MONTGOMERY COUNTY PLANNING DEPARTMENT
THE MARYLAND-NATIONAL CAPITAL PARK AND PLANNING COMMISSION

MEMORANDUM

REVIEW TYPE: Pre-Preliminary Plan of Subdivision

PROJECT NAME: Gottens Good Luck
CASE #: 720090120
REVIEW BASIS: Chapter 50, Montgomery County Subdivision Regulations, Section 50-35A(a)(8)

Figure 2: Preliminary Plan

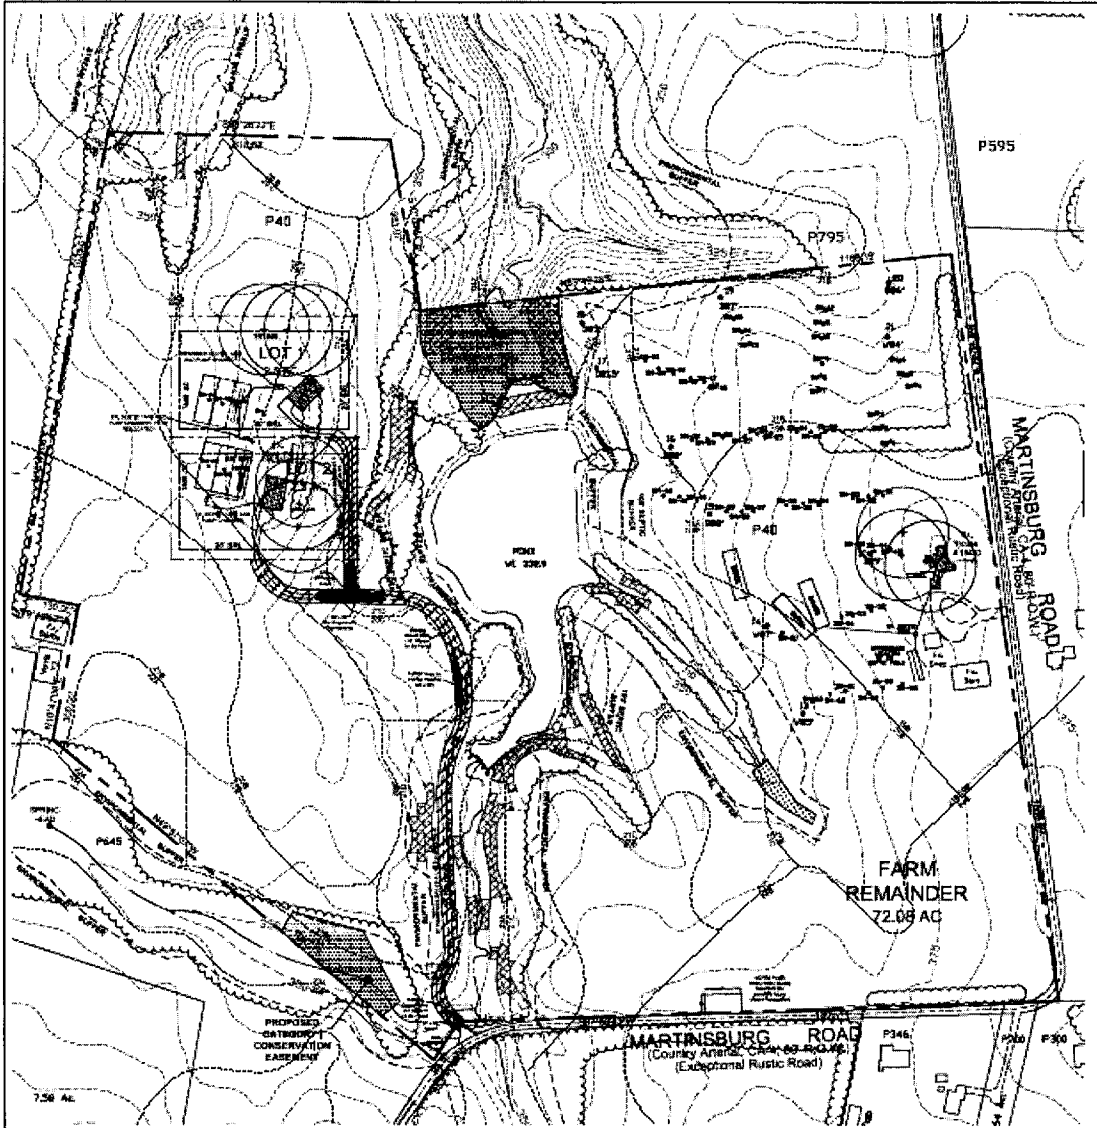
The Applicant proposes to record 2 lots, both 2.5 acres in size, for future construction of 2 one-family detached dwelling units. The lots are located in the western portion of the Property where the current tenant house is currently located. The existing tenant house is proposed to be removed to accommodate one of the lots. The remaining portion of the Property which includes the existing house and accessory structures is proposed to remain as a 72.08 acre farm remainder. The 2 new dwelling units are proposed to be served by private wells and sand mound septic systems. Access to the 2 lots is shown from Martinsburg Road using an existing 12-foot wide gravel driveway that must be paved to become a shared, private driveway to the 2 lots with a 30 foot-wide ingress/egress and utility easement over it. The 2 proposed lots have been located on the Property to minimize impacts to existing agricultural operations. As a result of this chosen layout, the Applicant has requested that the Planning Board approve the 2 lots on a private driveway absent public street frontage pursuant to Section 50-29(a)(2) of the Subdivision Regulations, which is discussed in greater detail below.

This Applicant requests the creation of 2 lots with no street frontage. The Applicant, in his justification, argues that this lot configuration will allow more acreage to stay in the farm remainder. Furthermore, a shared private driveway using the existing gravel farm road will minimize impacts to Martinsburg Road, an exceptional rustic road. The proposed 12-foot wide driveway access to the site is free and clear of any obstructions and will be suitable for the installation of underground utilities and emergency vehicle access once it is paved and pull-off areas for emergency vehicles to pass one another in the event of an emergency are provided to satisfy MCFRS requirements. A 30-foot wide ingress/egress and utility easement is proposed over the driveway to accommodate future installation of electrical and telecommunication utilities. Staff and Montgomery County Fire and Rescue concur that access is adequate to serve the lots for emergency vehicles. Therefore, staff recommends that the Board approve the proposed lots without frontage on a public road.

Based on Staff’s review, the proposed preliminary plan substantially conforms to the stated goals of preserving farms and farmland. The size and location of Lots 1 and 2 in previous applications fragmented the critical mass of the current farm, but were changed based on Staff’s recommendation to create smaller lots. The proposed lots avoid prime farm soils and do not substantially fragment the existing farm.

As submitted, an existing driveway will be used for the proposed houses to reduce new impacts to the road and maintain the present character along the Property frontage.

- 1) Approval under this preliminary plan is limited to 2 lots for 2 one-family detached residential dwelling units and an existing dwelling unit on an unrecorded farm parcel.

- 2) The Applicant must submit a final forest conservation plan to M-NCPPC staff for review and approval prior to recordation of the lot.
- 3) At the time of record plat application, the Applicant must provide verification to MNCPPC staff of the availability of a TDR for each of the proposed lots.

- 4) The record plat must reference a covenant that has been recorded on the unrecorded farm parcel to document that density and TDRs have been utilized to create the 2 proposed lots.

- 5) At the time of record plat application, the Applicant must provide verification to MNCPPC staff of approval by the Montgomery County Department of Permitting Services (MCDPS), Well and Septic Section of the proposed well and septic field locations.

- 6) The record plat must reflect common ingress/egress and utility easements over all shared driveways.
- 7) The record plat must contain the following note: "Agriculture is the preferred use in the Rural Density Transfer Zone. All agricultural operations shall be permitted at any time, including the operation of farm machinery, and no agricultural use shall be subject to restriction because it interferes with other uses permitted in the Zone."
